RECORD OF DECISION

Declaration, Decision Summary,
Response Summary

VOCs in Vadose Zone

**Indian Bend Wash
Superfund Site, South Area
Tempe, Arizona**

**FIGURE II-7
FACILITIES UNDER INVESTIGATION
INDIAN BEND WASH - SOUTH ROD**

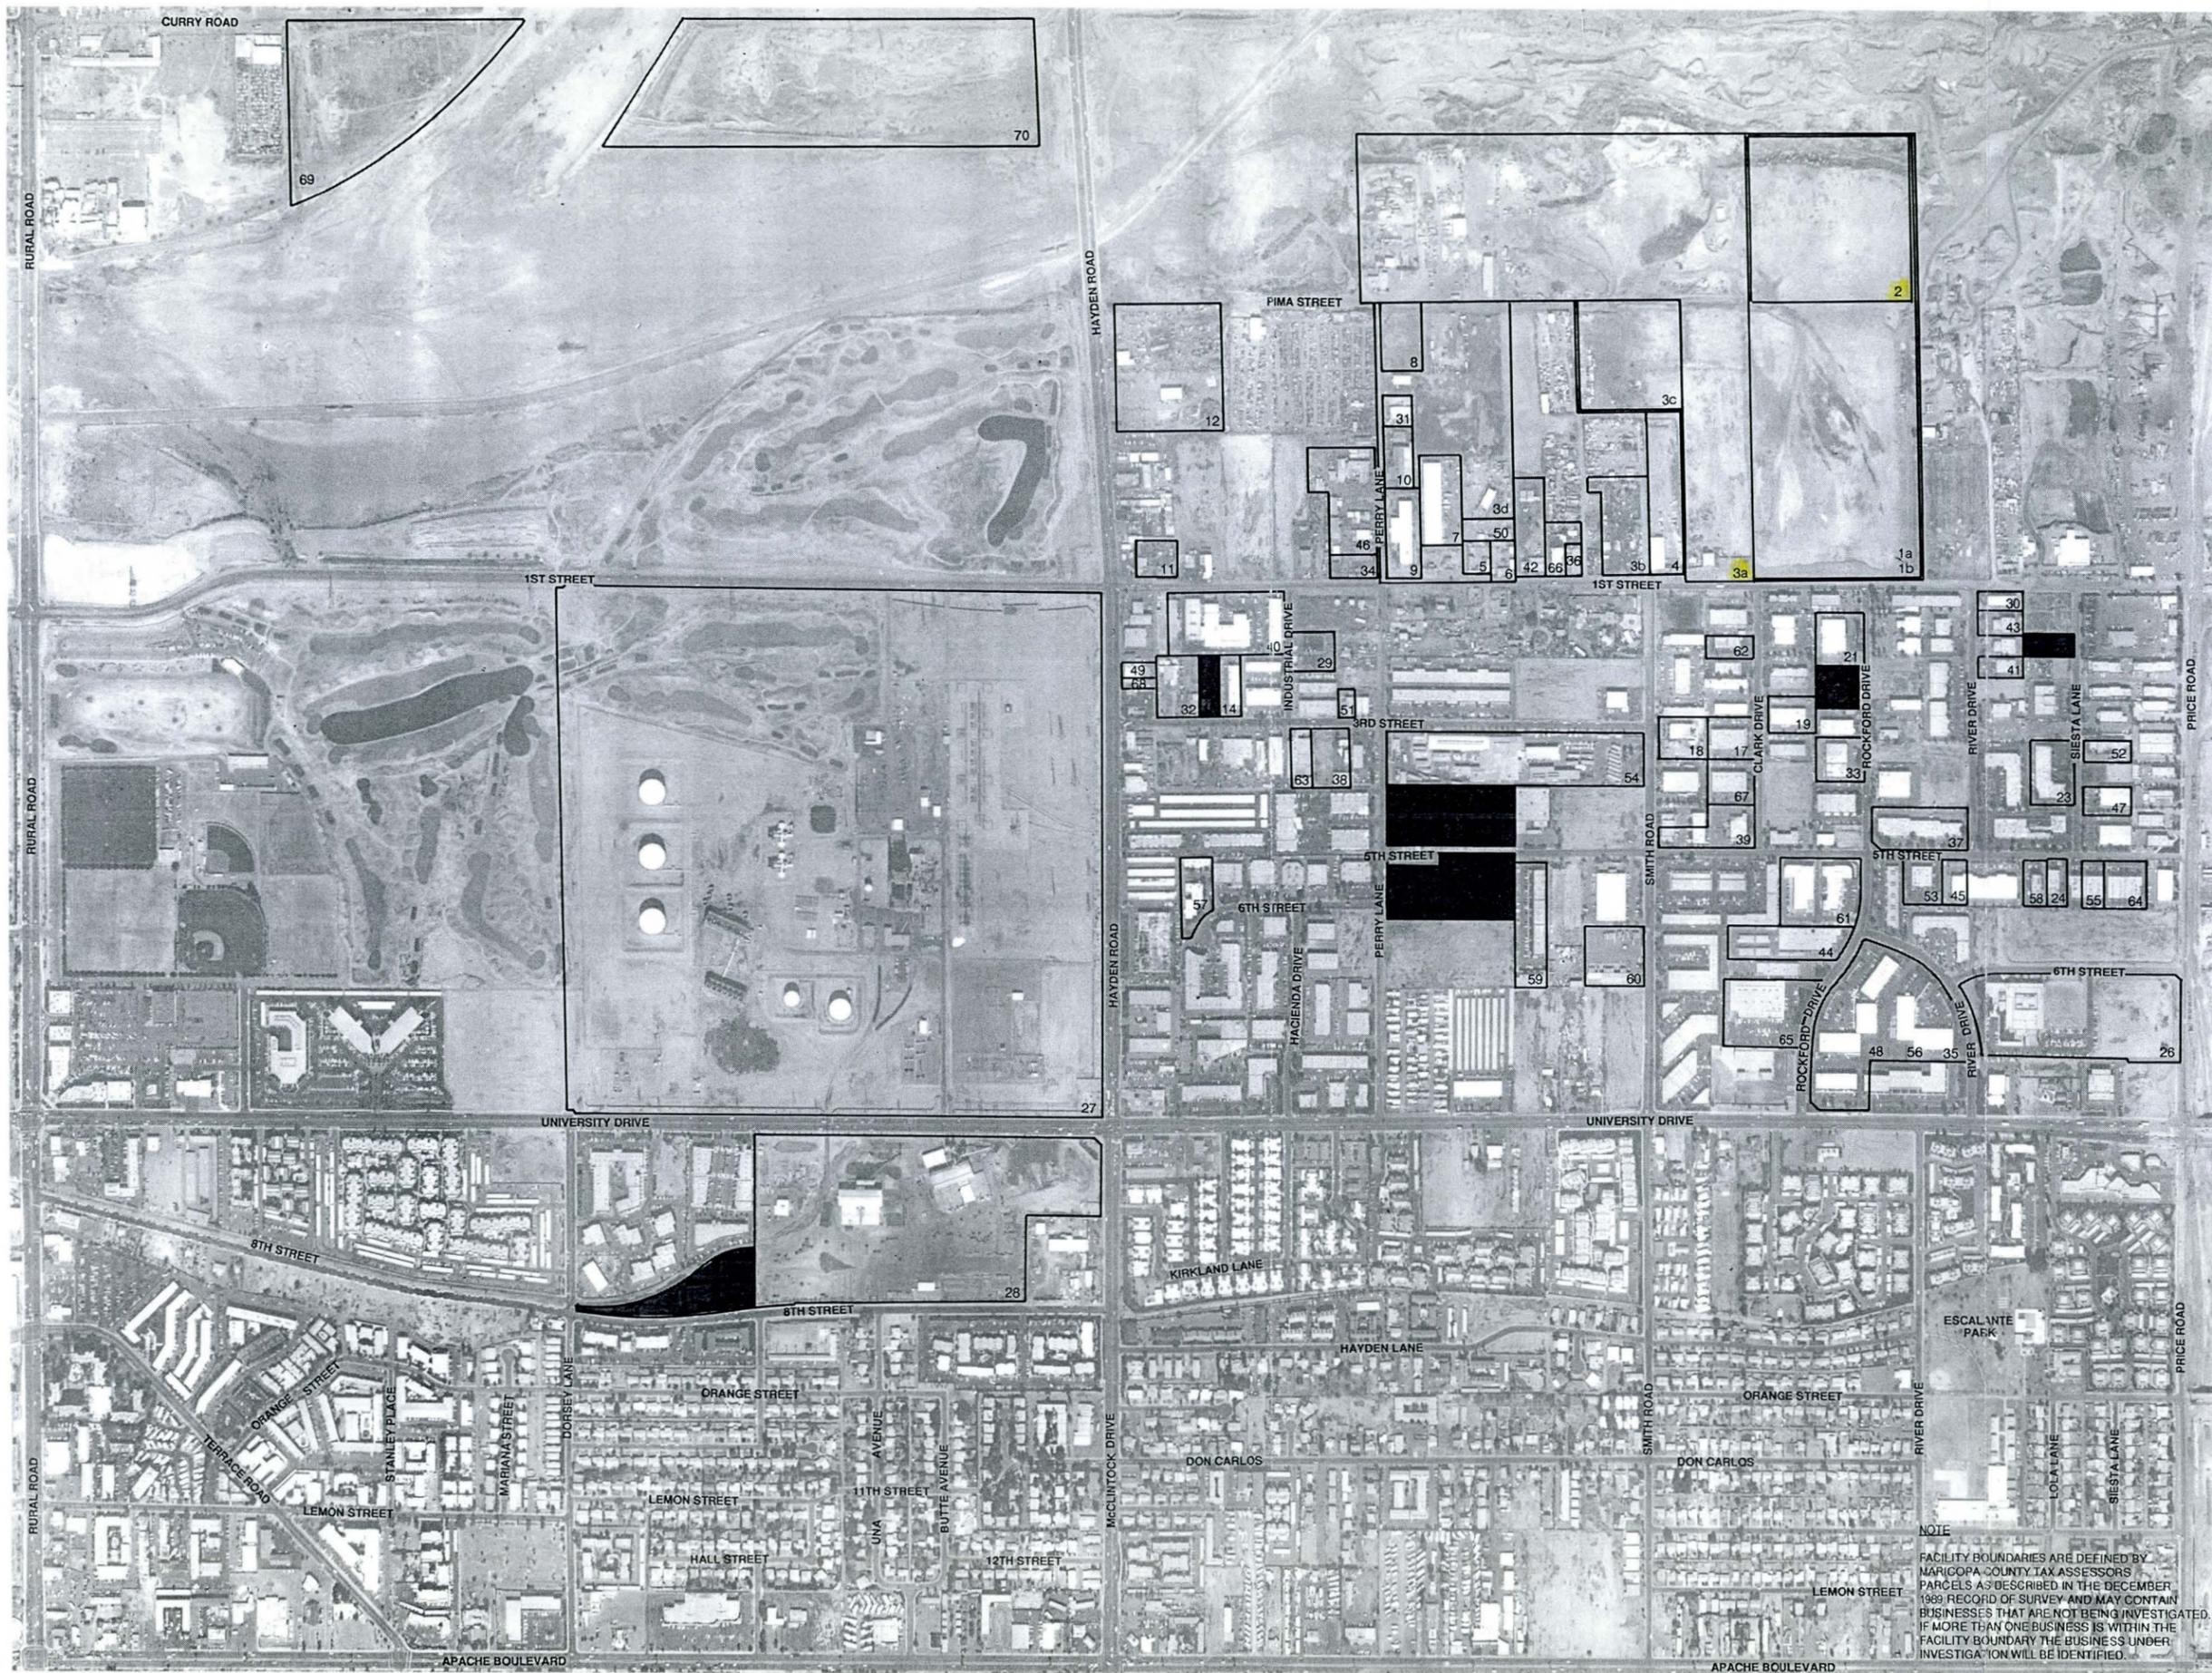
8. Figure 1-3 in the Feasibility Study was incorrectly labeled. This figure appears again in the ROD with the correct label. The figure shows about 70 facilities which represent the universe of facilities for which EPA has gathered investigation data. However, not all of these facilities will undergo focused RIs, as indicated by the label in the FS.

Figure 3 lists facilities planned to perform focused RIs. Publishing this list has significant impact on those facilities included in the list. APS recommends that EPA publish a list of facilities where no further action is required after the focused RIs are complete.

The title on Figure 3 was incorrect, and this is noted in the ROD. Figure 3 shows facilities that EPA has begun investigating or from which it has obtained information. The actual number of facilities undergoing full Focused RIs will be less than the number of facilities on Figure 3. Many facilities will be screened out without requiring a Focused RI.
